Product / Process Change Notification (PCN)

<p>PCN #: PCN_conTBL3_20230616</p> <p>Affected Series: WE-TBL 3 6913124100xx, 6913134100xx, 6913174100xx, 6913177100xx</p> <p>PCN Date: March 16, 2023</p> <p>Effective Date: June 16, 2023</p>	<p>Change Category:</p> <p><input type="checkbox"/> Equipment / Location <input checked="" type="checkbox"/> General Data <input type="checkbox"/> Material <input type="checkbox"/> Process <input type="checkbox"/> Product Design <input type="checkbox"/> Shipping / Packaging <input type="checkbox"/> Supplier <input type="checkbox"/> Software</p>
<p>Contact: Product Management</p> <p>Phone: +49 (0) 7942 - 945 5001</p> <p>Fax: +49 (0) 7942 - 945 5179</p> <p>E-Mail: pcn.eican@we-online.com</p>	<p>Data Sheet Change: <input checked="" type="checkbox"/> Yes <input type="checkbox"/> No</p> <p>Attachment: <input type="checkbox"/> Yes <input checked="" type="checkbox"/> No</p>

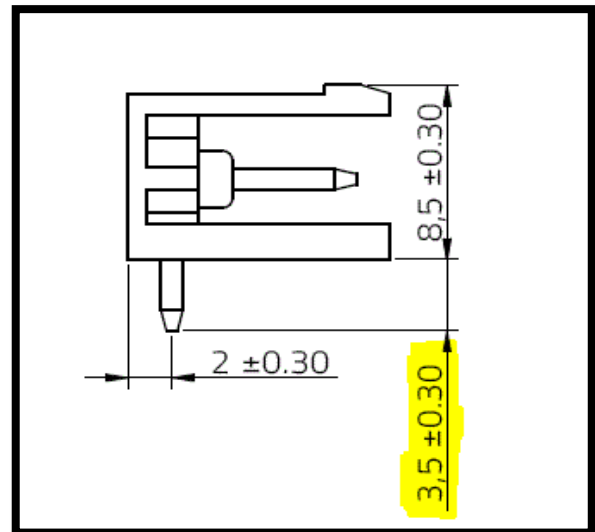
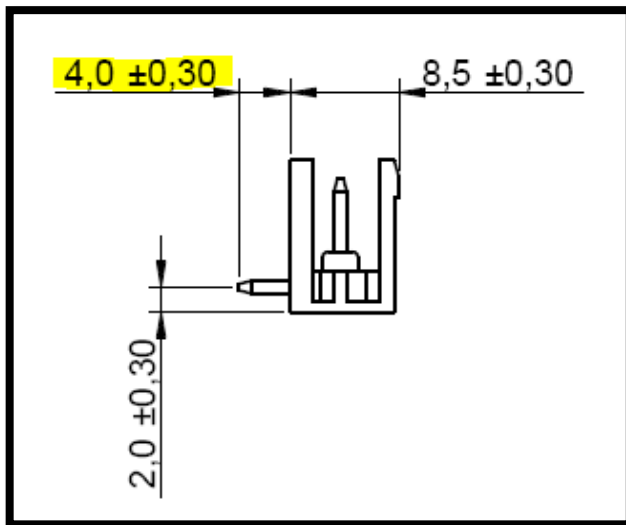
Description and purpose of change:
 As a datasheet information amendment, Würth Elektronik will correct the length of the pin, which does not correspond to the length of the actual product.
 This is a datasheet correction only. There will be no change in form, fit, function, quality or reliability of the product.

Detail of Change:
 The Length 4 mm is incorrect and will be changed to 3.5mm.

Change Details	L (mm)
BEFORE	4
AFTER	3.5
